STATEMENT OF RESPONSE TO LRD OPINION

**Proposed Large-scale Residential
Development**

**Lands at Elmfield,
Ninth Lock Road, Clondalkin,
Dublin 22.**

Applicant: Thornmeadow Developments Limited.

Figure 2 – Proposed Layout/Massing of the proposed development with indicative connectivity also shown.

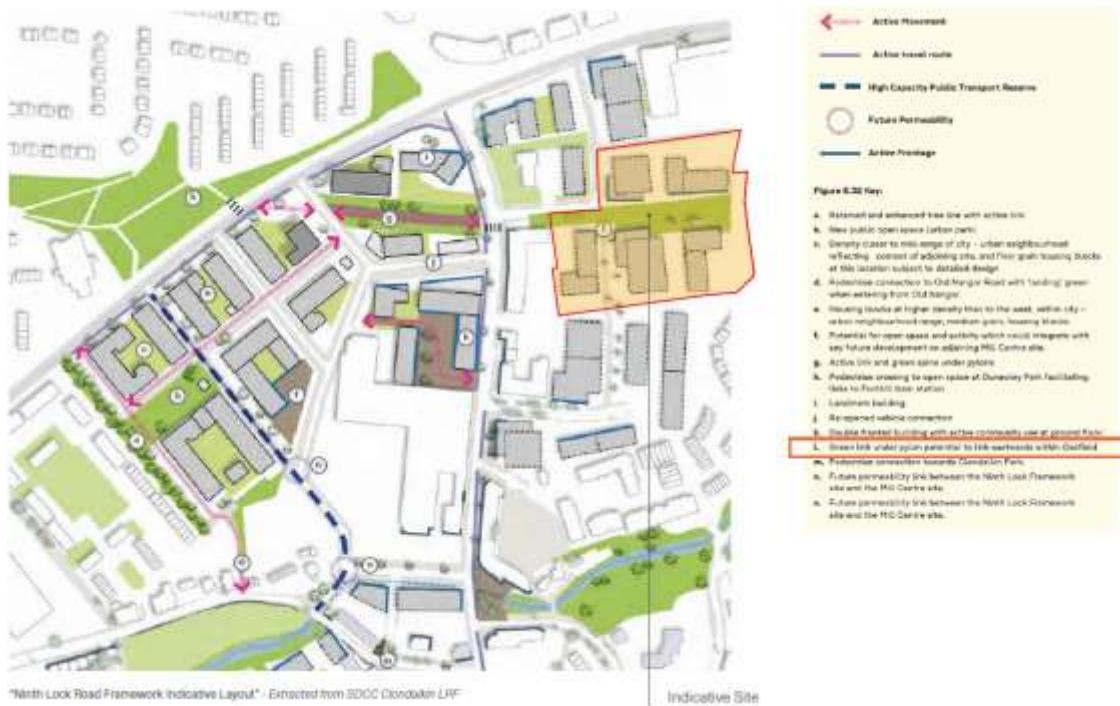
The applicant should detail compliance with the relevant policies and objectives of the Clondalkin Local Planning Framework as well as include details of how the scheme will integrate and reflect the historic Clondalkin Village.

At a high level, a comparison between the indicative layout within the LPF (Figure 1 below) and the proposed site layout Plan (Figure 2 below), shows the similarity between both. The main urban form and layout are consistent in their approach, with the central area of open space running east-west through the site and acting as a green link from Ninth Lock Road to Riversdale in the east. The proposed development also facilitates future connectivity beyond the site, such as with the cycle path to the east as well as potential future cycle, pedestrian or road connections to the north and the south, which could connect with any future redevelopment of the adjoining sites. The overall heights and density proposed as well as land uses are also consistent.

The main east-west link of the proposed development provides for active ground floor spaces with the childcare facility and also own-door units providing activity along this key corridor.
